Response to Comments

WALK HILL RESIDENCES

ROSLINDALE, MASSACHUSETTS

MARCH 16, 2017

Figure 4 Parking Level Plan

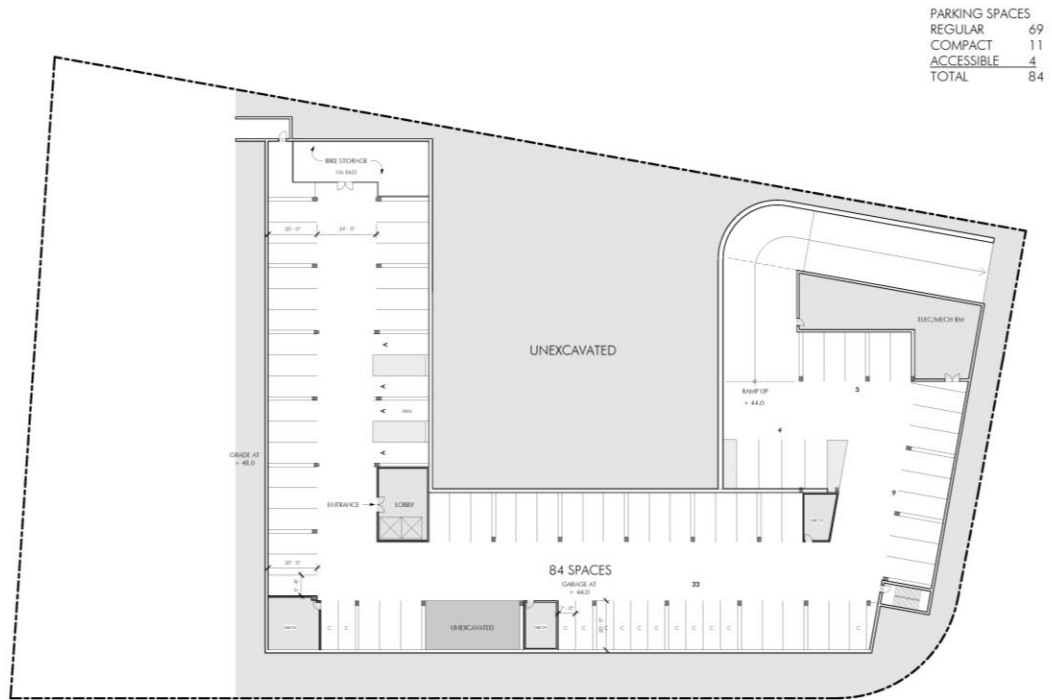
Comment: Regarding bicycle storage, provide count of spaces provided, indicate storage location on plans insuring easily accessible from both outside and residences and indicate any repair facilities.

Comment: Accessible Parking – confirm count and location

Response: The schematic plans have a dedicated, enclosed, bicycle storage area in the parking garage sufficient for one bike per unit per BTM standards. The final location and access arrangement will be addressed with the building design.

Response: The Handicapped Parking spaces are shown on the floor plans.
